Local Planning Panel

184-200 Broadway, Chippendale NSW 2008

D/2024/1165

Alterations and additions to existing commercial building for use as a backpackers accommodation including:

Clause 4.6 Variation Request - Height

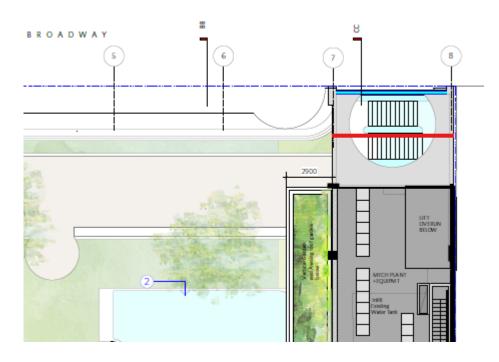
- existing maximum building height is retained
- the existing plant area on the east of the site is being extended towards
 Broadway to align with the building frontage
- provides a stairwell and architectural feature
- no adverse amenity impacts

Clause 4.6 Variation Request - FSR

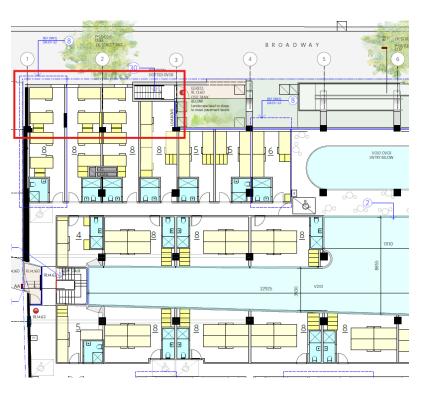
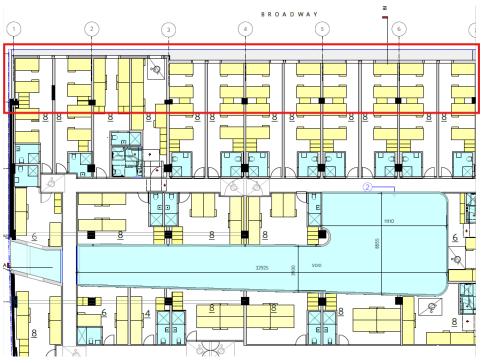
- existing building is over FSR
- the development involves removal of floor space to make way for the void
- facade being brought forward to the Broadway boundary to align with neighbouring sites
- considered to be a positive design outcome
- no adverse amenity impacts

Poor room amenity (first floor)

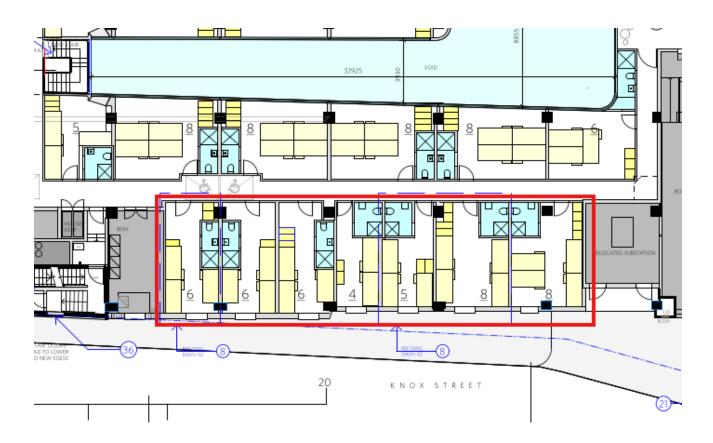
- seven rooms comprising of 43 beds on level 1 have poor amenity
- rooms have windows fronting Knox Street at street level
- privacy and natural light cannot be achieved
- recommended to be removed and replaced with common space
